H TECHNICAL

HT250US

TRAILER AIR SUSPENSION

No: TRAILER AUS - 013

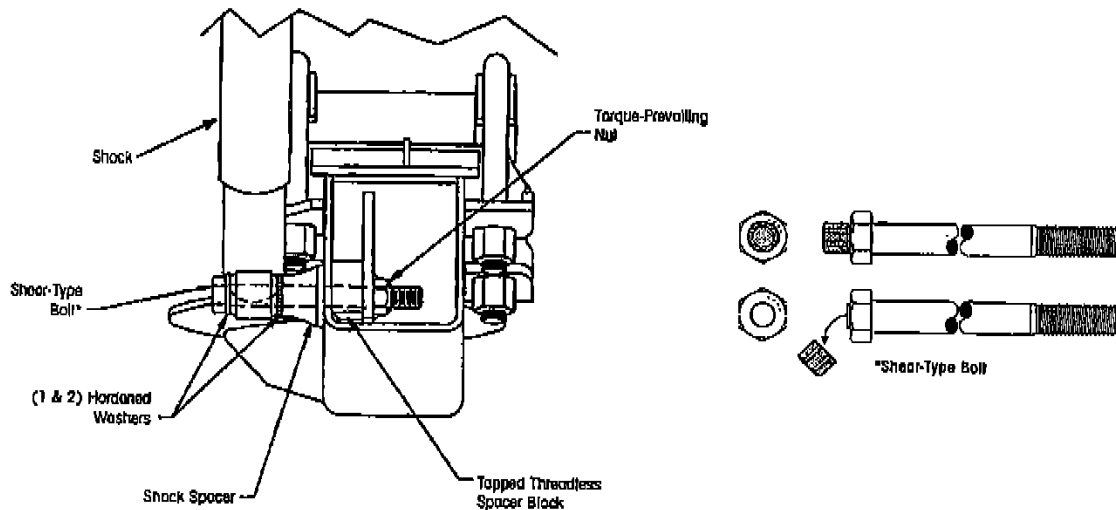
As part of our continuous product improvement program, Hendrickson has revised the lower shock mount.

Effective March, Hendrickson will make the following changes to improve product reliability. (ref figure)

- ? Shear type, coarse thread bolt to ensure proper torque. (Part No. B-24058-2)
- ? New shock absorber with stronger inner metal bush to withstand higher torque. (Part No. S-23743 / 7.5"-14", S-23744 / 5.5" & 6.5")
- ? Additional hardened washer between spacer and shocker.
- ? Revised spacers with more support inside and outside beam.
- ? Torque prevailing nut tack welded to the spacer inside the suspension beam.

The current design utilises a large nut with threads inside the beam. The current nut will be replaced with a similar spacer block with no internal threads. A torque prevailing nut will be tack welded to the spacer to accept the new shear bolt.

The shear bolt is a convenient feature to achieve the correct clamp load. The bolt is designed to torque at 210-235 ft.lbs. Proper torque is critical to the life of these shock mounting connections.

New shocks are also being introduced with this design. Two shocks are available depending on suspension ride height. Refer page one for part numbers. The inner metal in the bushing area has been strengthened to withstand the higher fastener torque. The form, fit and function of these shockers will not change.

The new shocks may be used in place of present shocks, however older shocks must not be used with the new shock mount design.
